Technical Service Bulletin (TSB)
Park Assist Sensor 3 and 4 Harness Swap

REFERENCE:	TSB: 08-222-26 GROUP: 08 - Electrical	Date:	May 27, 2026	REVISION:	—
VEHICLES AFFECTED:	2027 (RU) Chrysler Pacifica / Voyager This bulletin applies to vehicles built on or after February 24, 2026 (MDH 0224XX) and on or before March 30, 2026 (MDH 0330XX) equipped with Parksense FR/RR Park Assist W/STOP (Sales Code XH4).			MARKET APPLICABILITY: ☒ NA☐ MEA ☐ SA☐ IAP ☐ EE☐ CH NOTE: This bulletin applies to the North America markets.	
CUSTOMER SYMPTOM:	There are no customer symptoms.				
CAUSE:	Park assist sensor harness connectors #3 and #4 are swapped.

Fig. 1
Park Assist Sensor Wire Harness Connector

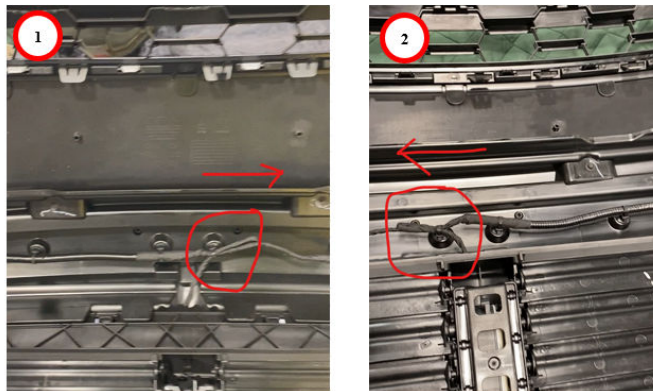
- 1 - Correct wire harness connector routing to park assist sensor #3 and #4.
2 - Incorrect wire harness connector routing to park assist sensor #3 and #4.

This bulletin provides information regarding the wire harness connectors for Park Assist Sensors #3 and #4. The harnesses for these sensors are visually identical and may have been interchanged during vehicle assembly.

If diagnosis indicates a concern related to Park Assist Sensors #3 or #4, or associated wiring, visually inspect the harness connections to verify correct installation before proceeding with further repair [Fig. 1](#).

If the connectors are found to be swapped, release the harnesses from the retaining clips as necessary, disconnect, and reinstall each connector to the correct sensor location. Ensure harnesses are properly secured after repositioning.
